VIRGINIA ELECTRIC AND POWER COMPANY  
RICHMOND, VIRGINIA 23261

**VIRGINIA ELECTRIC AND POWER COMPANY**  
**SURRY POWER STATION UNITS 1 AND 2**  
**PROPOSED LICENSE AMENDMENT REQUEST**  
**RELOCATION OF AUGMENTED INSPECTION REQUIREMENTS**  
**FROM TS 4.2 AND TS 4.15 TO TECHNICAL REQUIREMENTS MANUAL**

**MARKED-UP TECHNICAL SPECIFICATIONS AND BASES PAGES**

**MAIN STEAM AND FEEDWATER LINES - UNIT 2**  
**SURRY POWER STATION**  
**UNITS 1 AND 2**

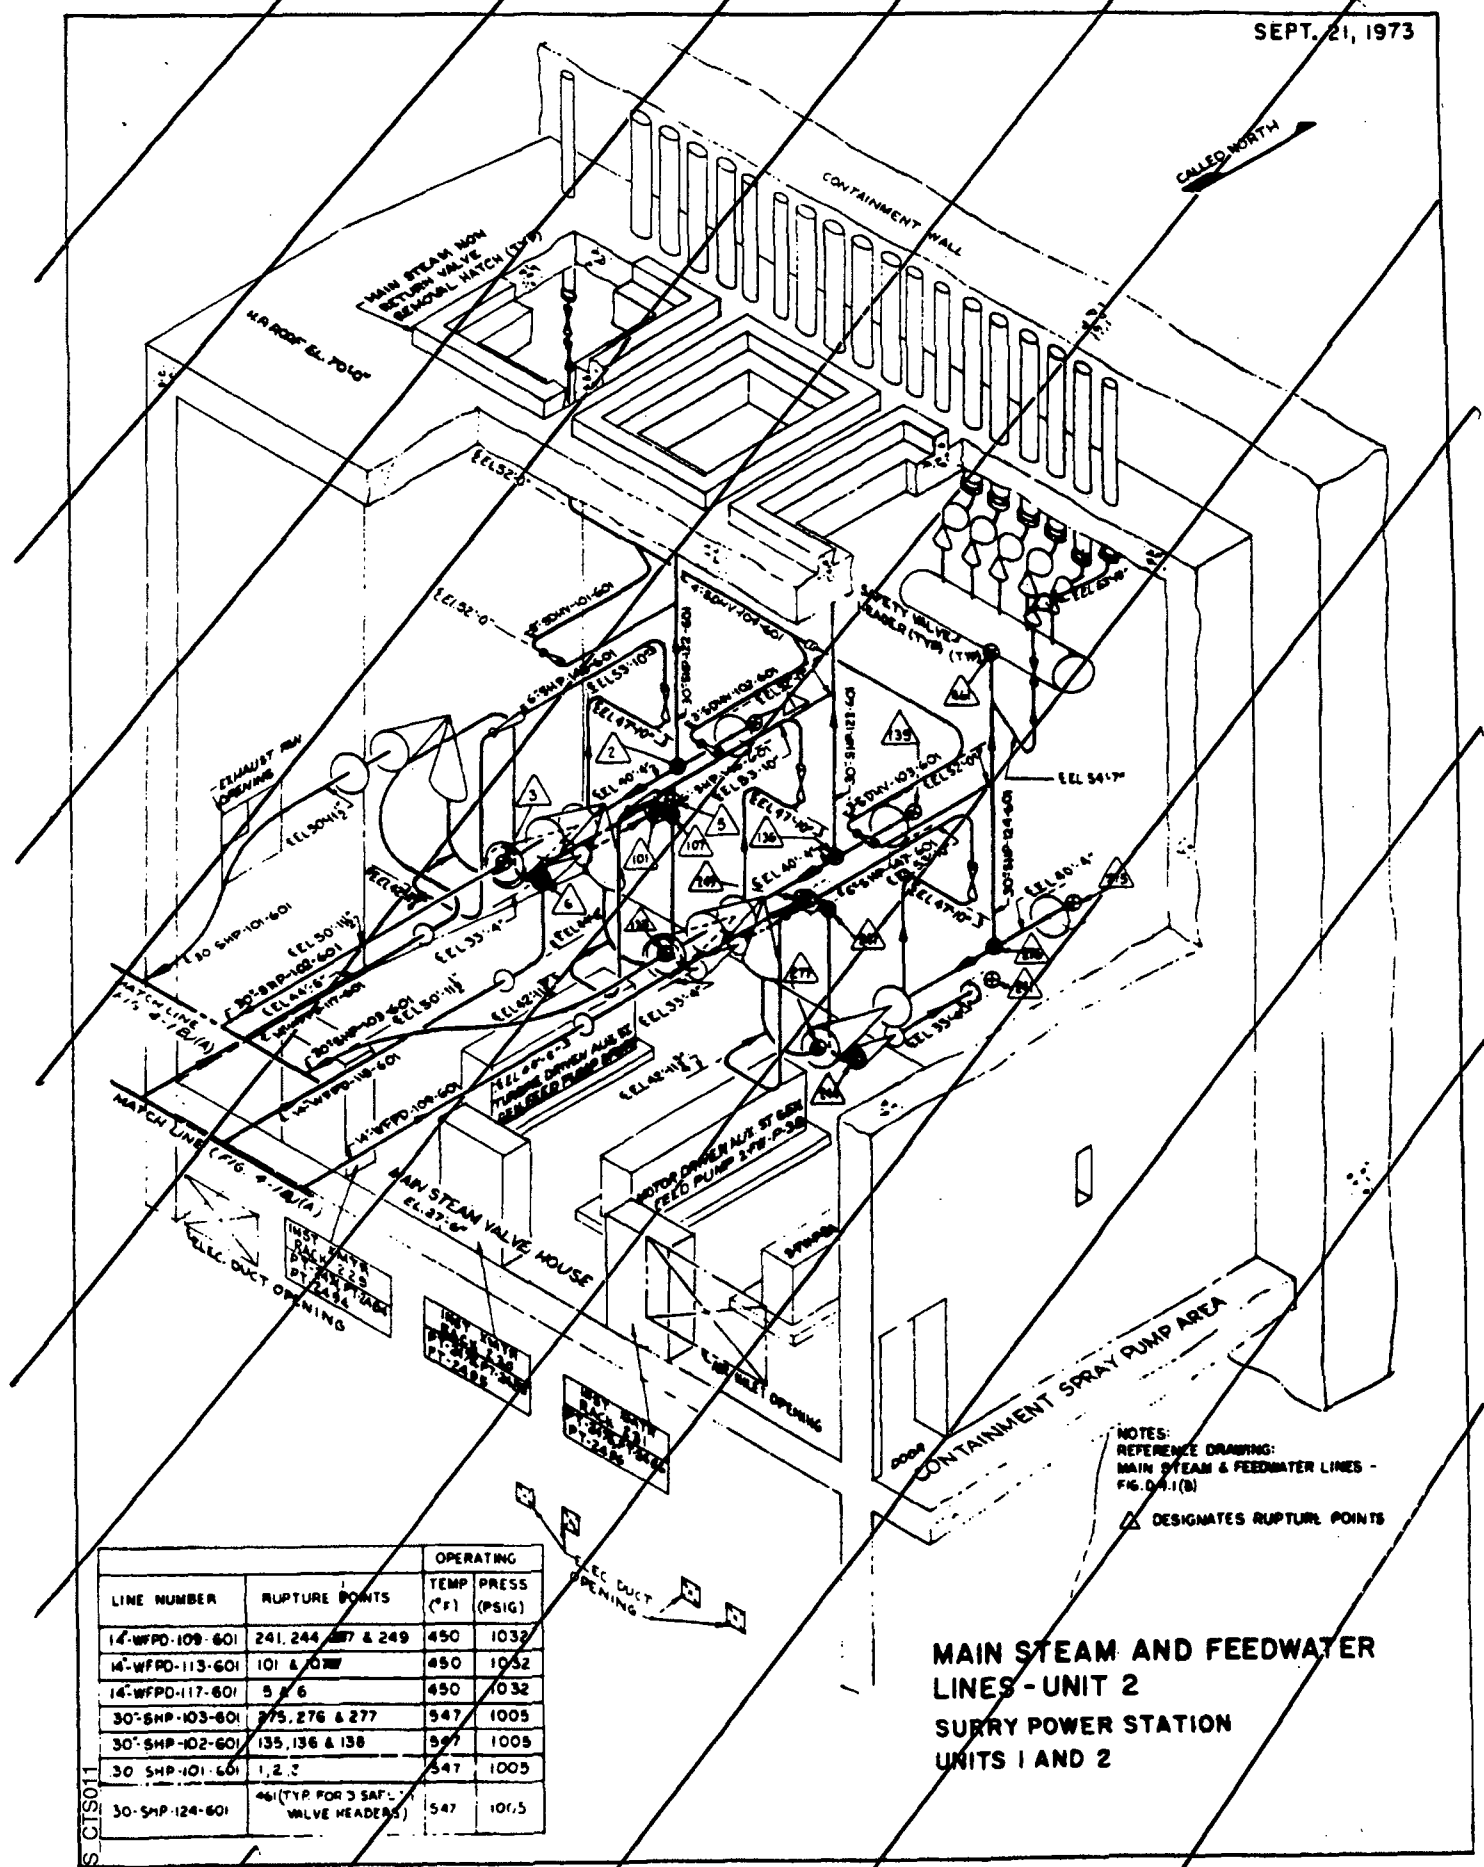
Pages TS 4.15-2 through TS 4.15-4 and TS Figure 4.15  
have been deleted.
